FEDERAL HIGHWAY ADMINISTRATION
FINDING OF NO SIGNIFICANT IMPACT

Project Number: IM 90-6(111)298

Project Name: I-90 East Belgrade Interchange

Gallatin County, Montana

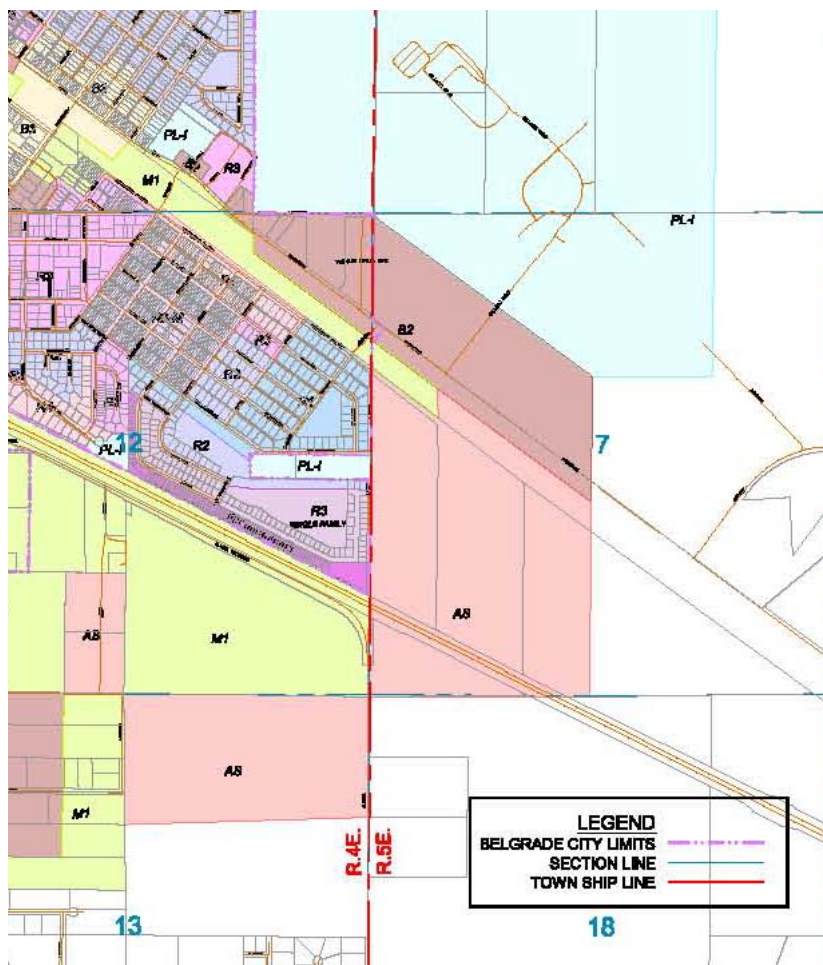
The City of Belgrade requested inclusion of an updated Zoning Map to replace the previous map displayed at Figure 3-1 on page 3-2 of the EA. Below is the updated map.

- Figure 3-1 Belgrade Zoning Map is out of date and the current Belgrade Zoning Map of this area should be used.

See new map included in the Edits/Corrections section of the FONSI.
